HILL EAST PARCELS B1 + B2

WASHINGTON, DC
GTM ARCHITECTS DC PROJECT #21.0515

ZONING COMMISSION
District of Columbia
CASE NO. 24-008
EXHIBIT NO. 2A3

PENTHOUSE PLAN / MAIN ROOF PLAN | A1.10

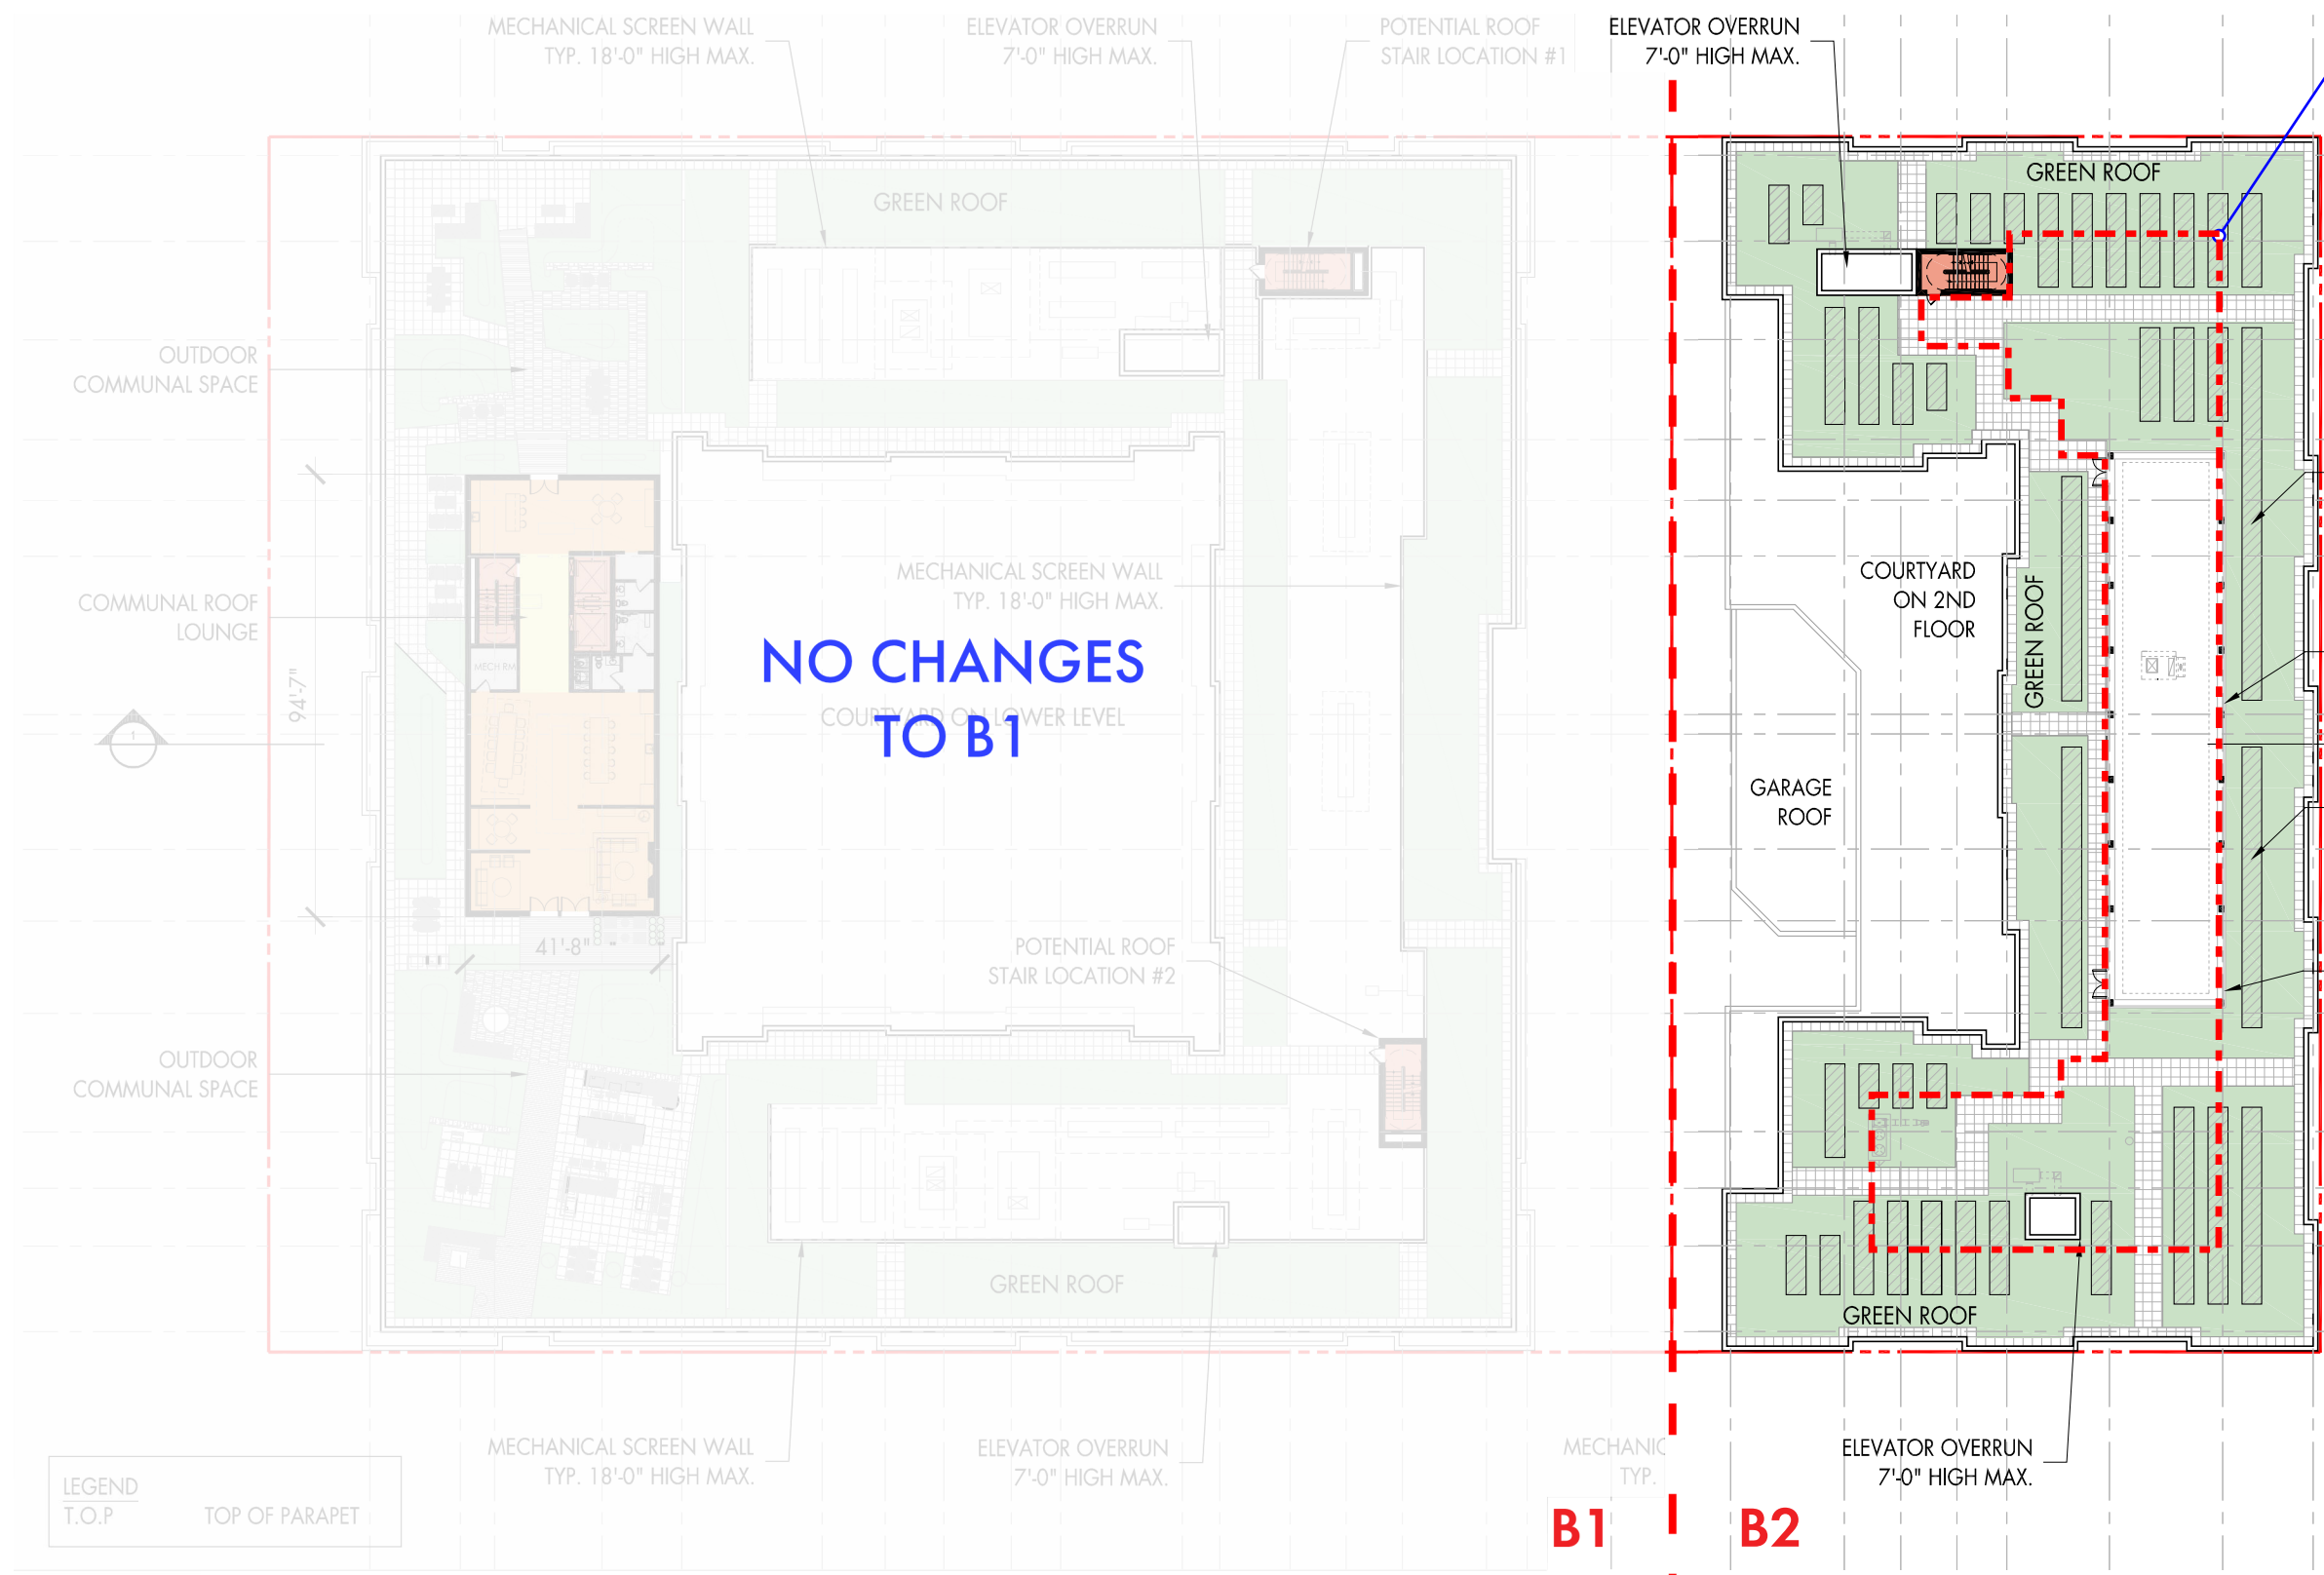
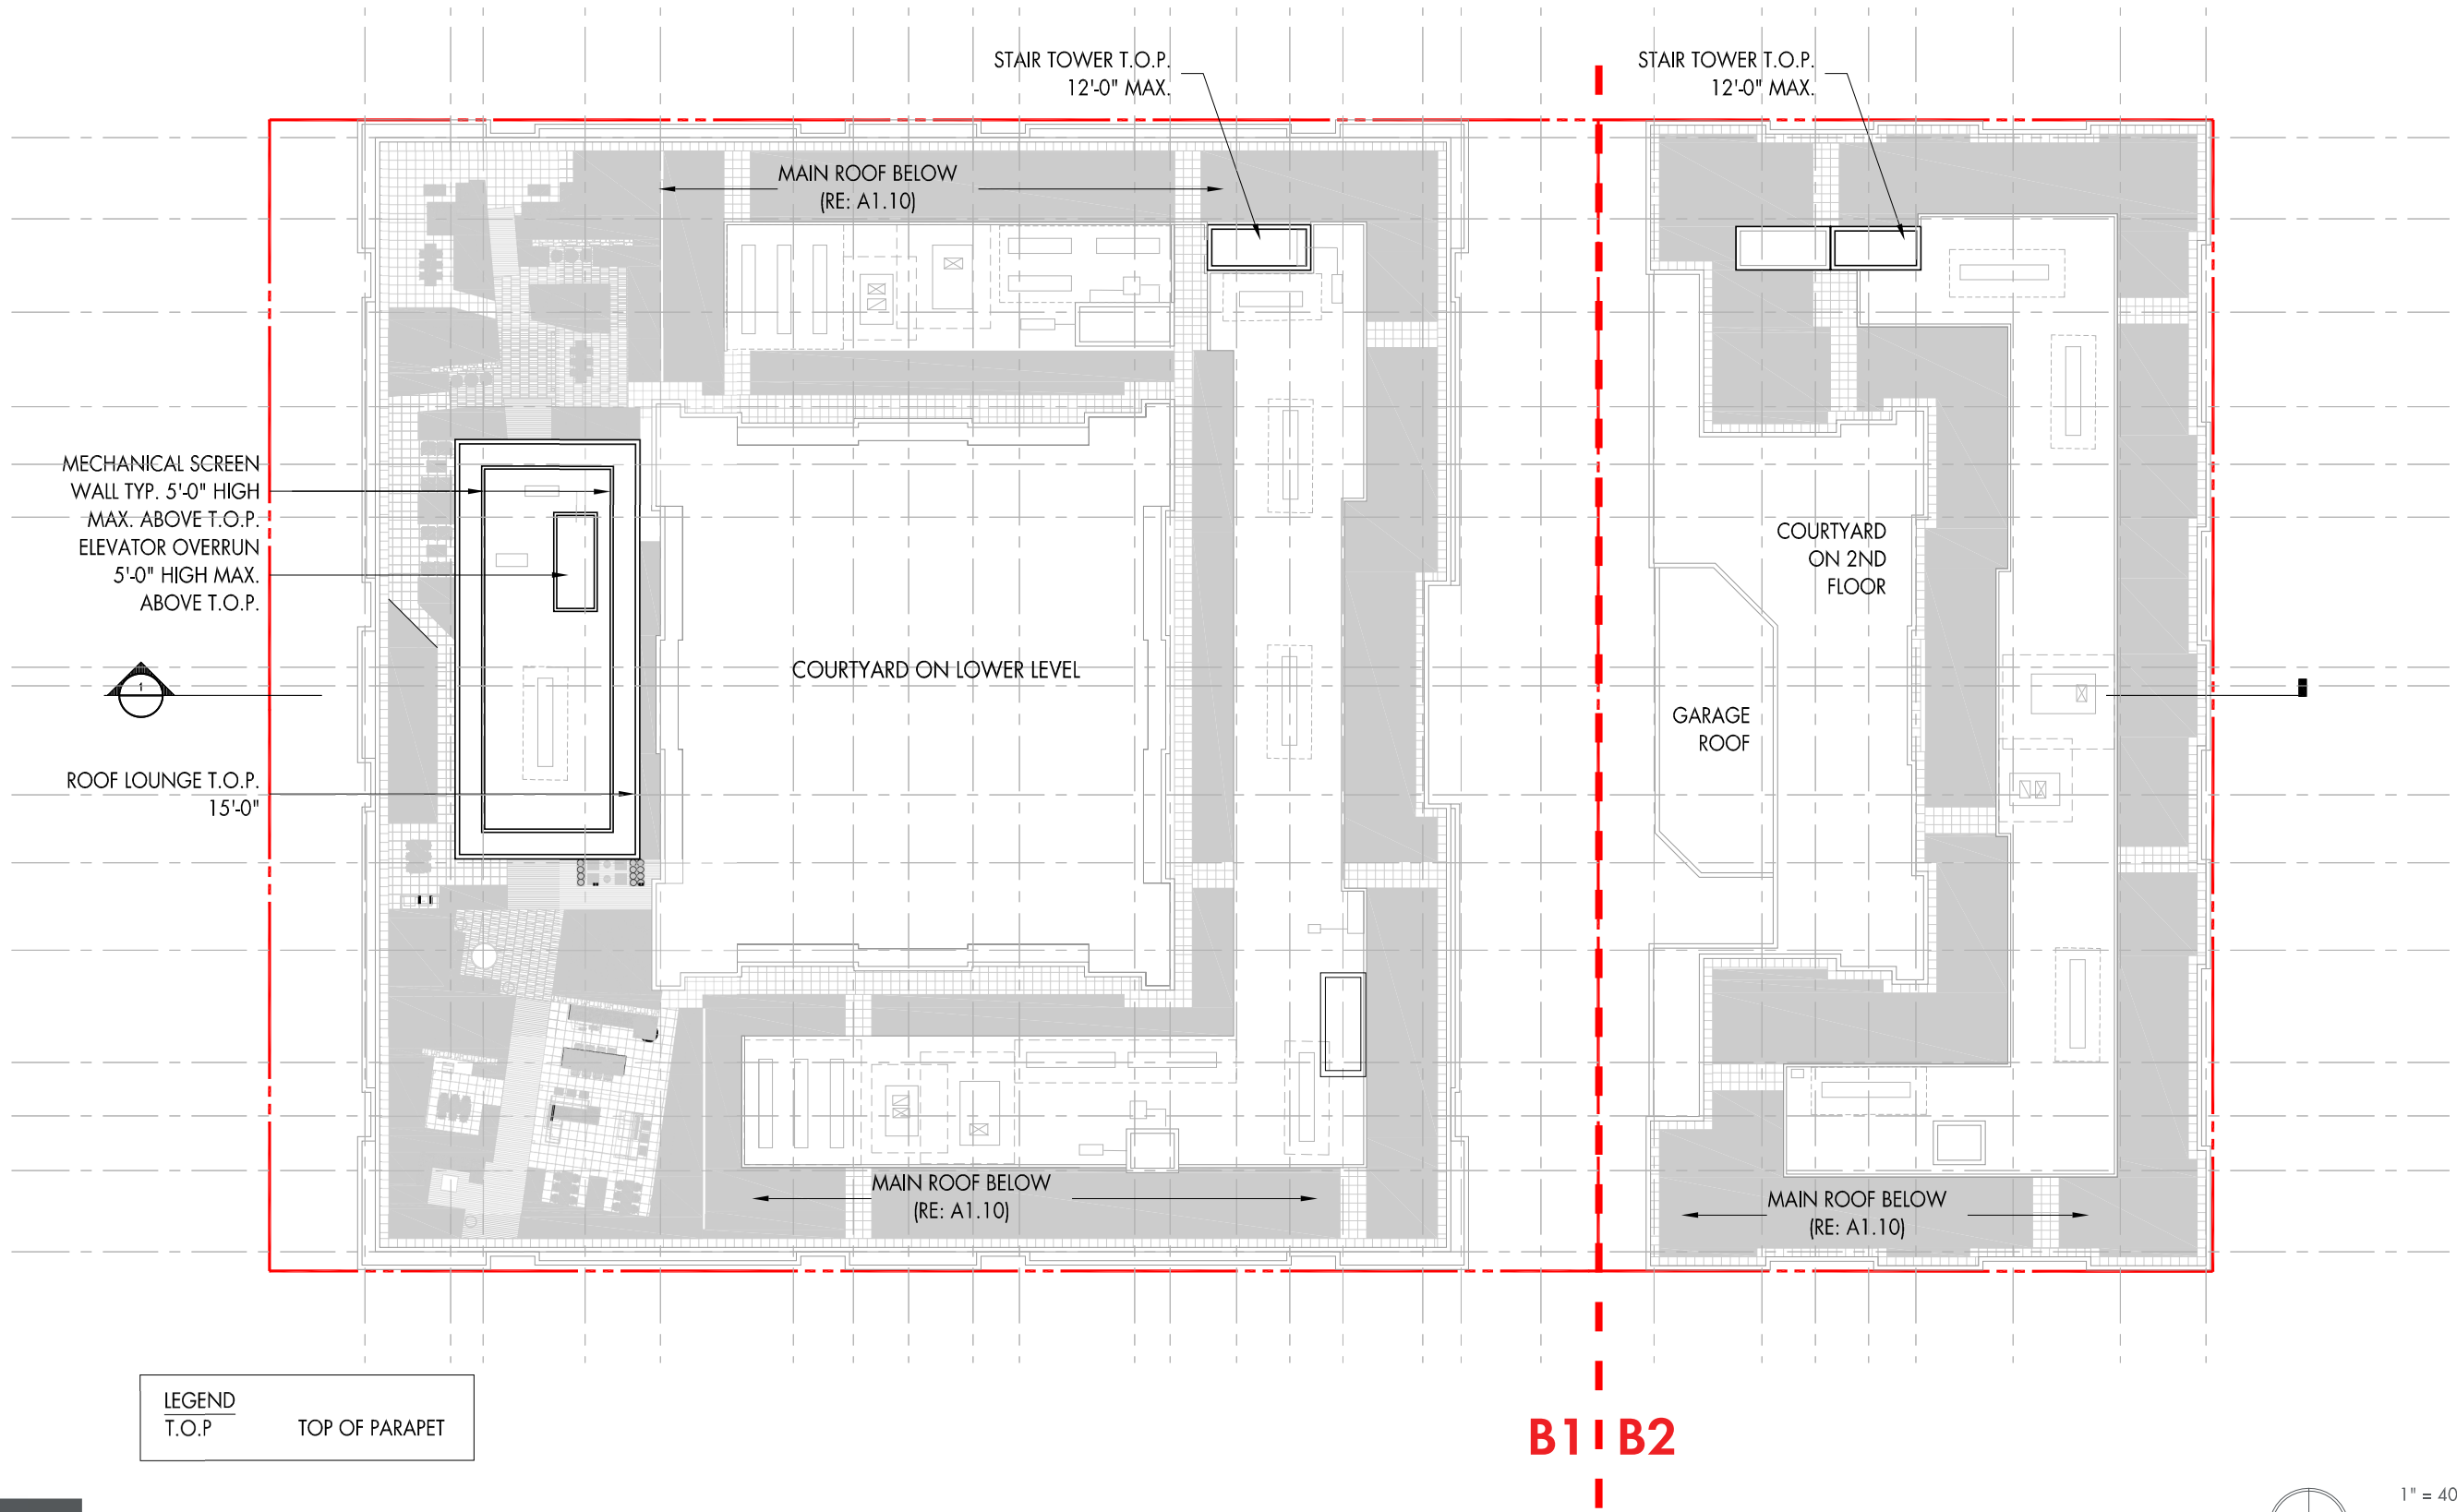
AREA OF MODIFICATION

NOTE: MECHANICAL SCREENWALL REDUCED IN SIZE TO ALLOW FOR SOLAR PANELS.

UPPER ROOF PLAN | A1.11

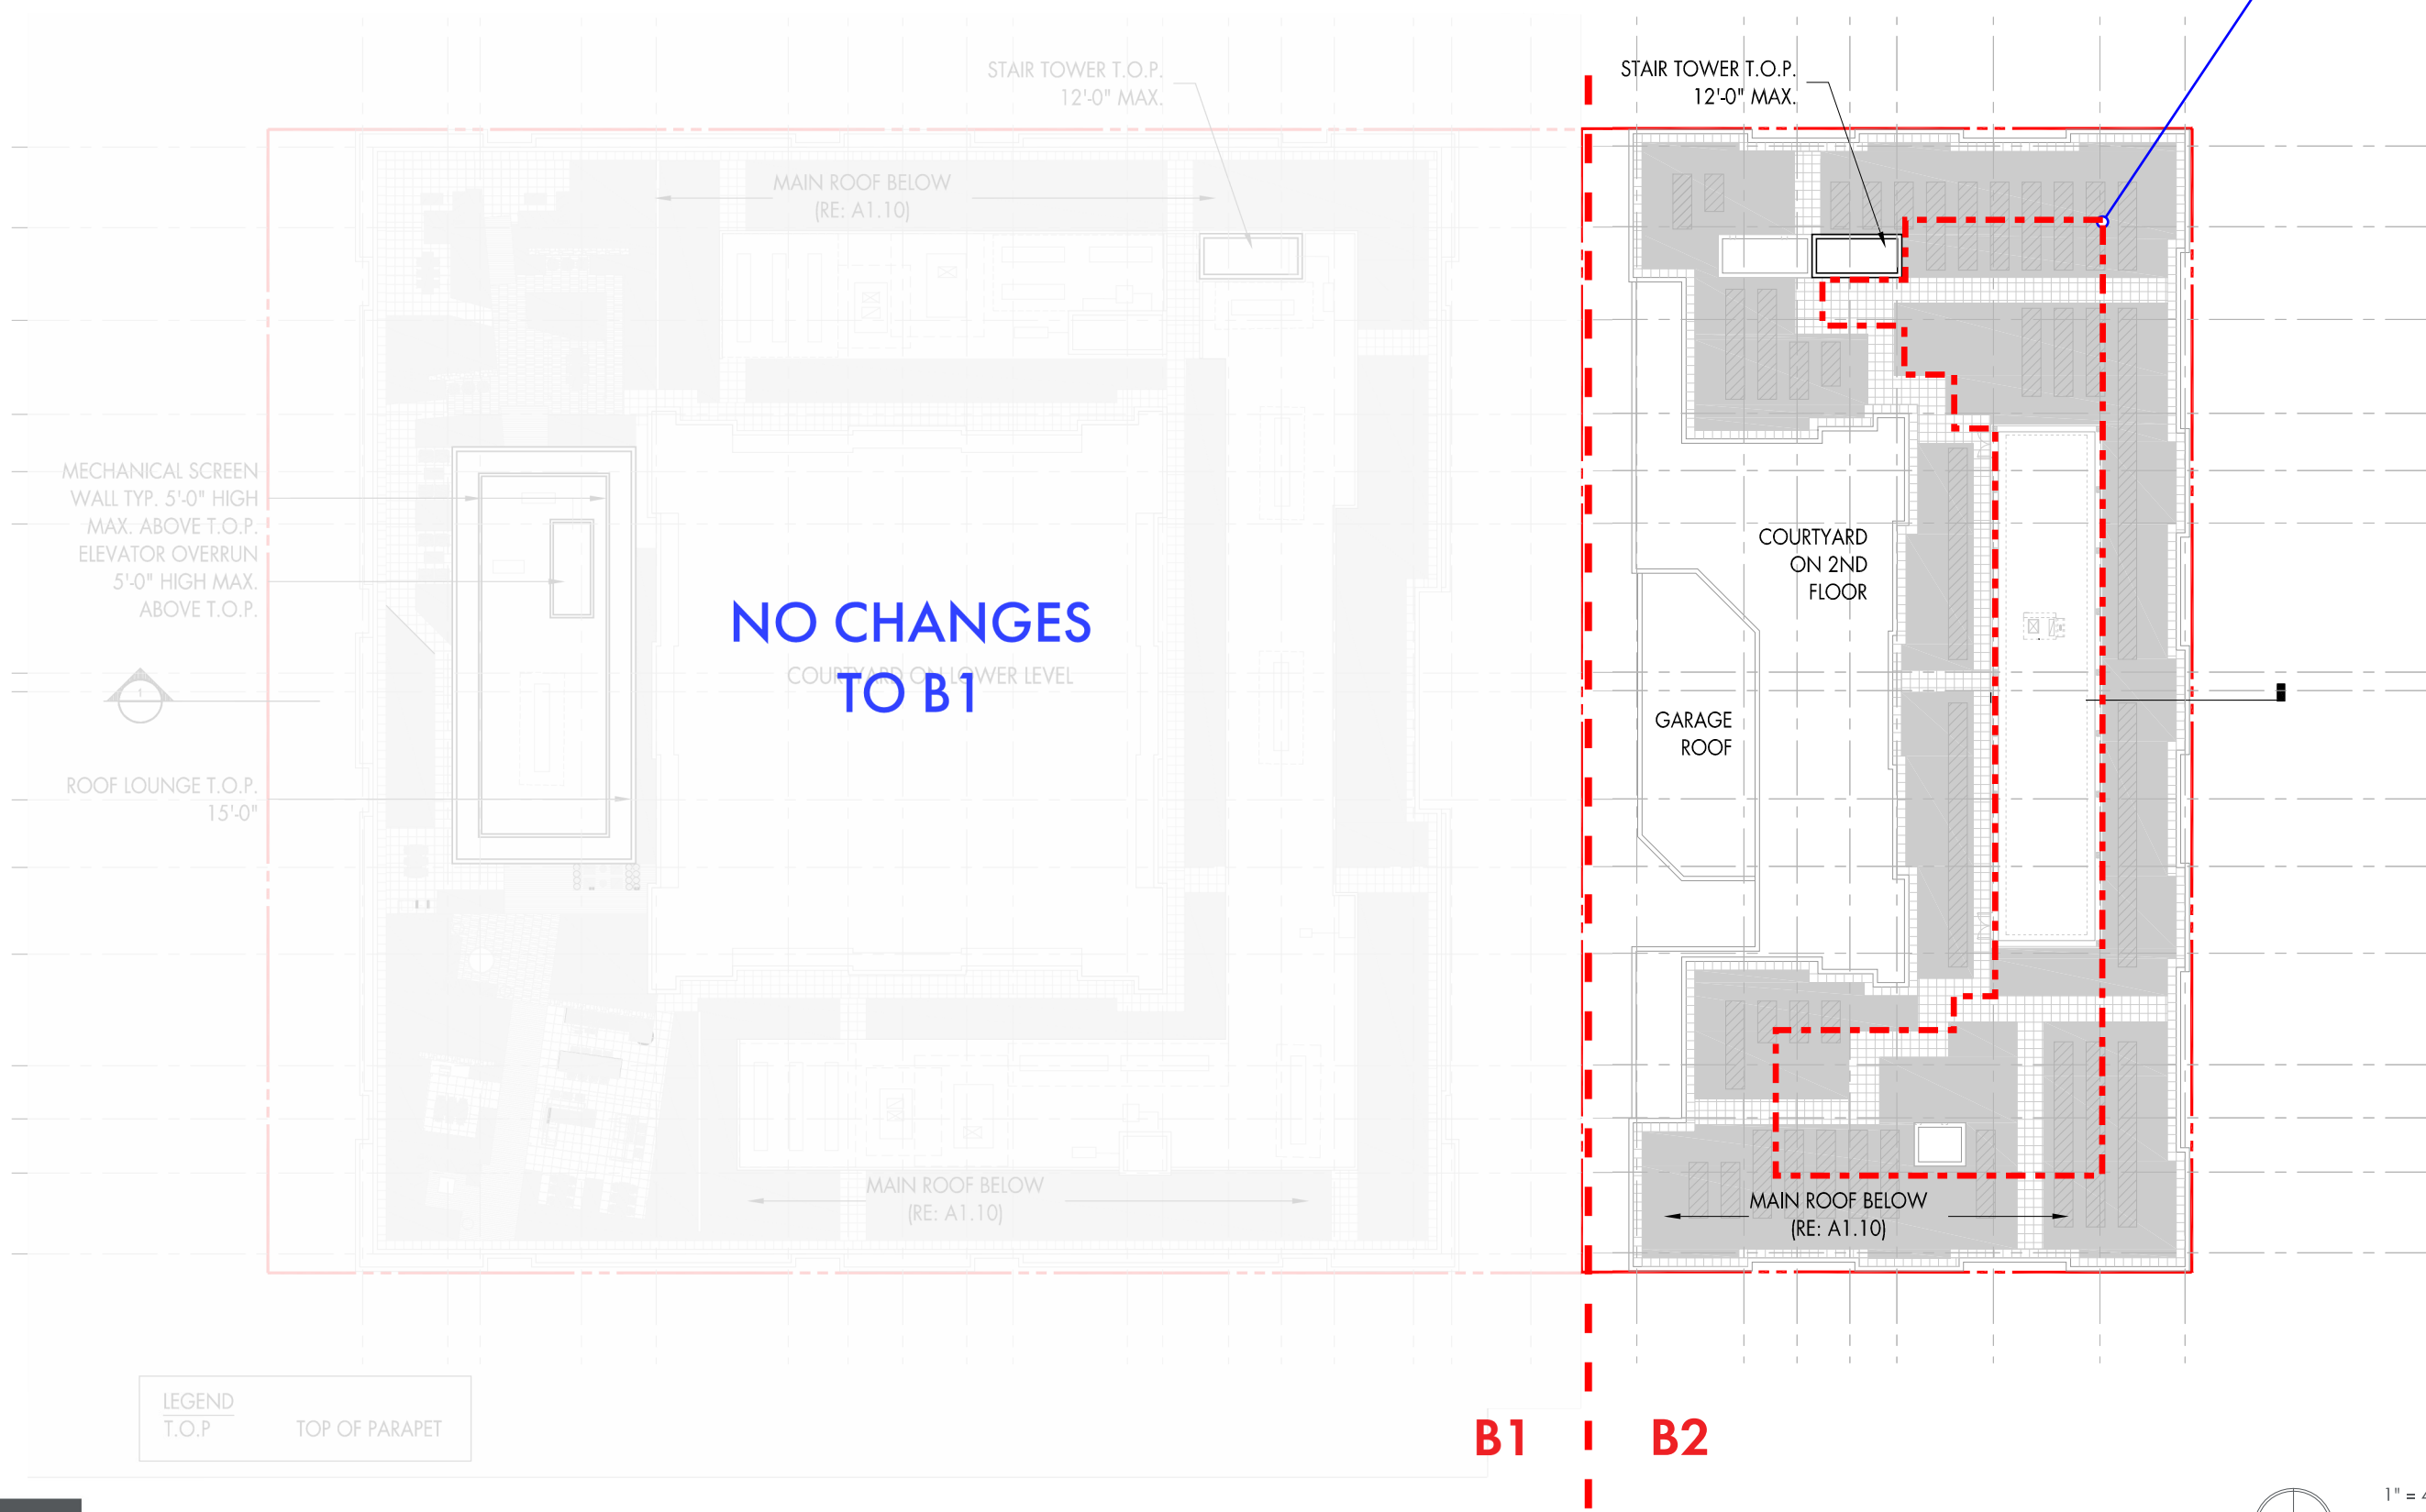
AREA OF MODIFICATION

NOTE: MECHANICAL SCREENWALL
REDUCED IN SIZE TO ALLOW FOR
SOLAR PANELS.
